PLAN COMMISSION AGENDA ITEM EXECUTIVE SUMMARY

Project Title/Address:	Parkside Reserves, 1337 Geneva Rd.		
City Staff:	Ellen Johnson, Planner		
PUBLIC HEARING 9/19/17	X	MEETING 9/19/17	X

Staff Report

RE: Parkside Reserves – 1337 Geneva Rd.

FRONT ELEVATION
 SCALE: 1/4" = 1'-0"

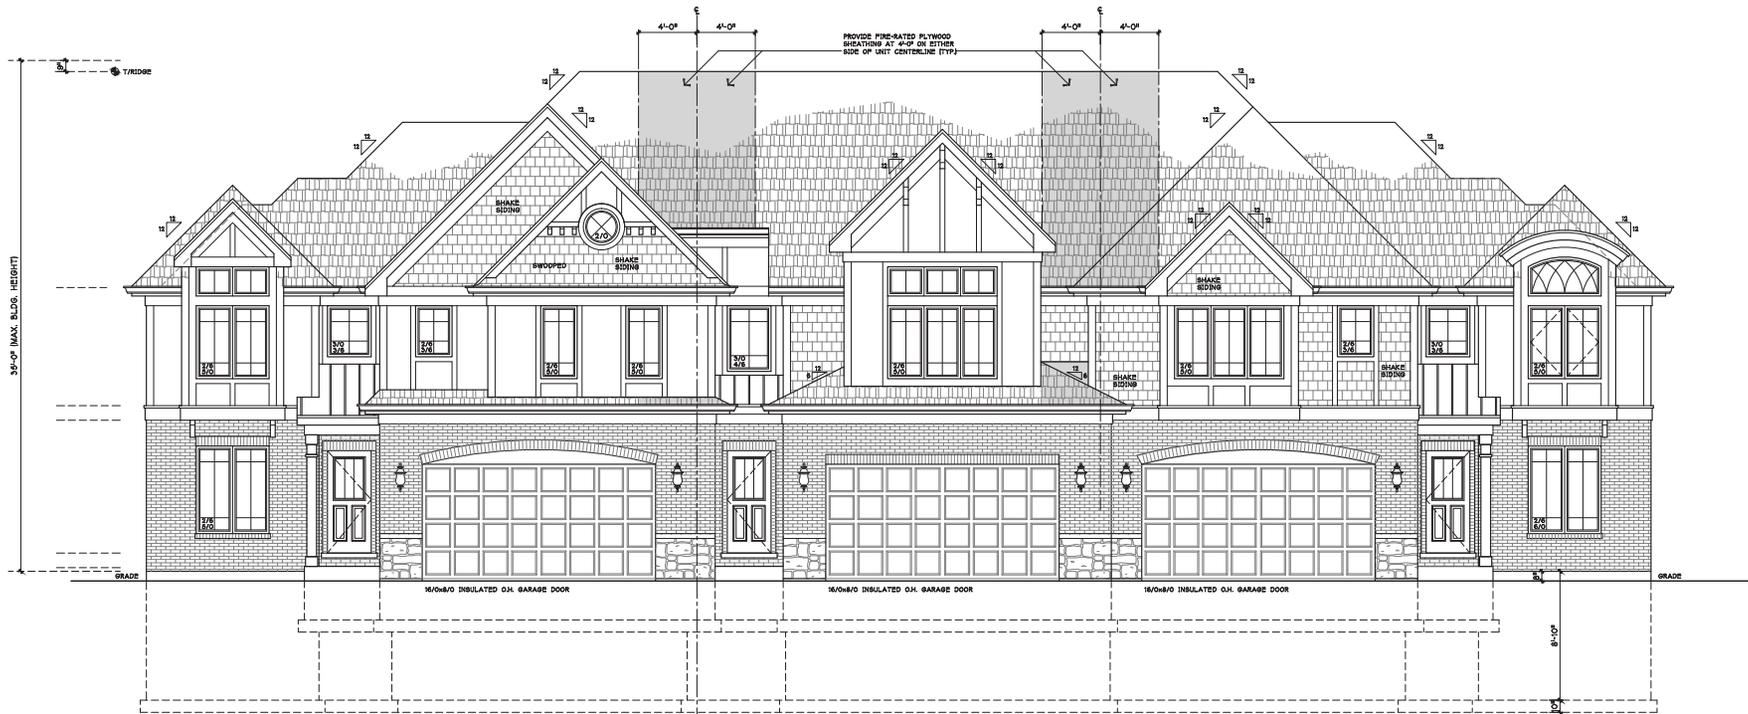
- Per the Zoning Ordinance, building height is measured as the vertical distance from grade at the midpoint of the required front building setback to the top of the ridge of the highest point of the roof. The building height is marked on the architectural elevations as just under 35 ft. However, grade at the midpoint of the front building setback (30 ft.) is approximately 3 ft. lower than grade at the building foundation, meaning the building height is greater than 35 ft. The building will need to be modified to meet the height limitation.

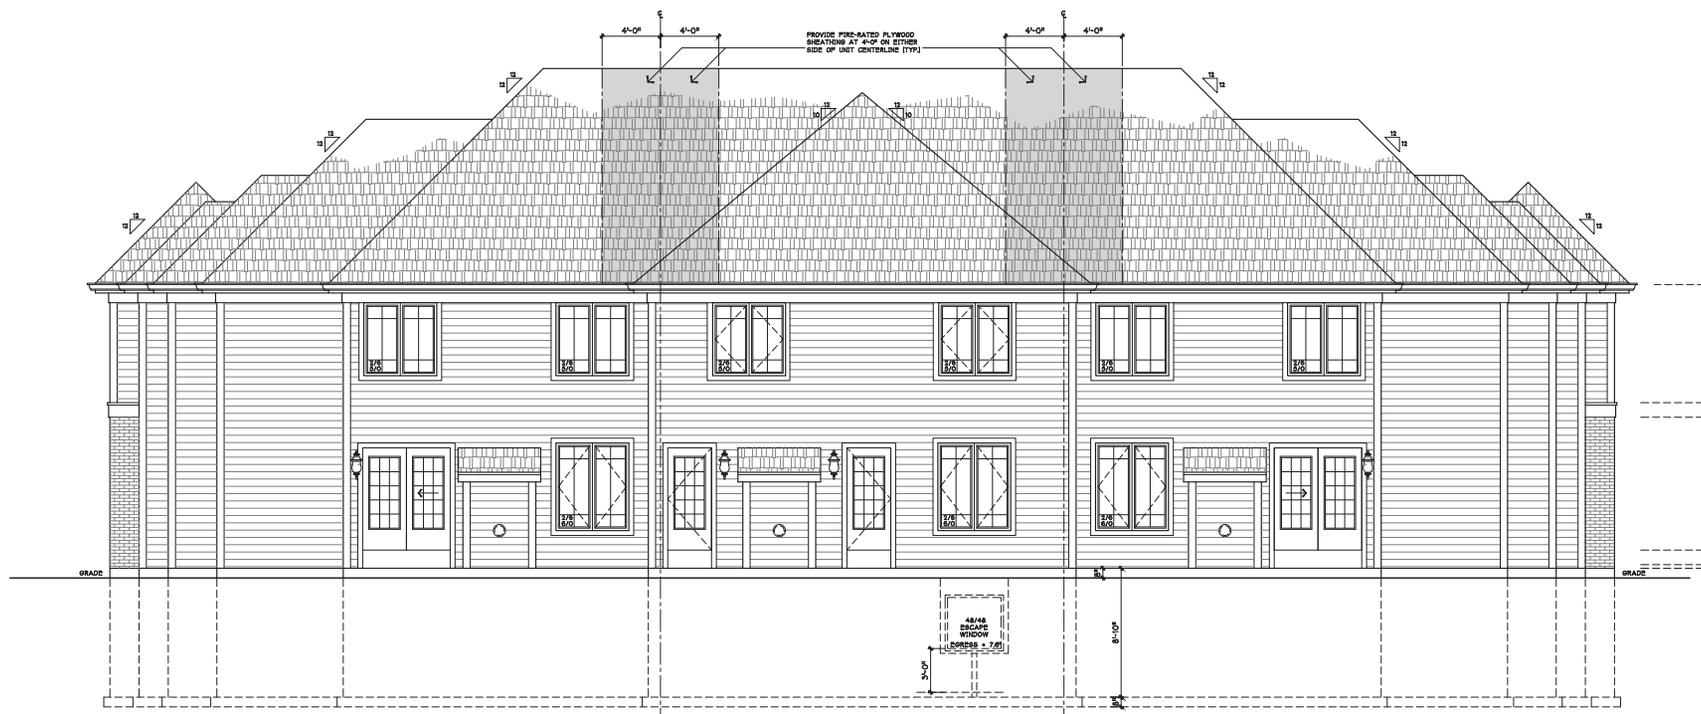
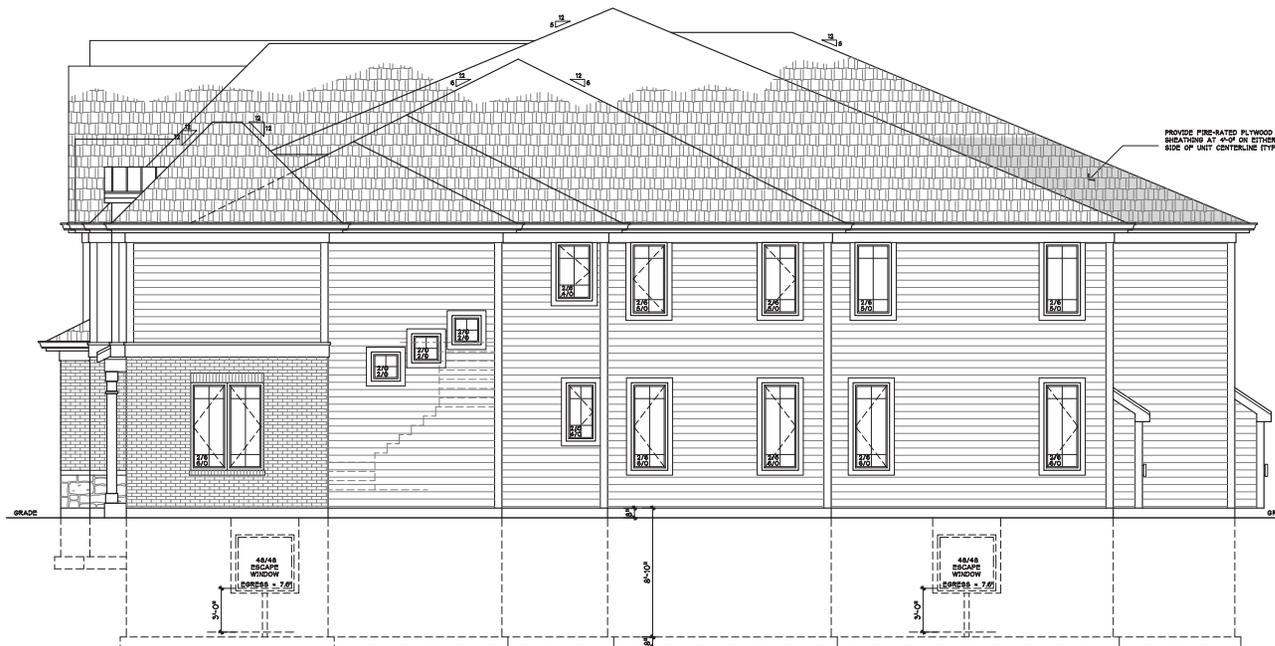
- Use of uniform exterior building materials is required on all facades. This requirement is not met as shown; brick, shake siding and wood or fiber-cement panels are used on the front elevation and horizontal siding is used on the sides and rear.
- Vinyl and aluminum siding are prohibited. Siding must be wood or fiber-cement.
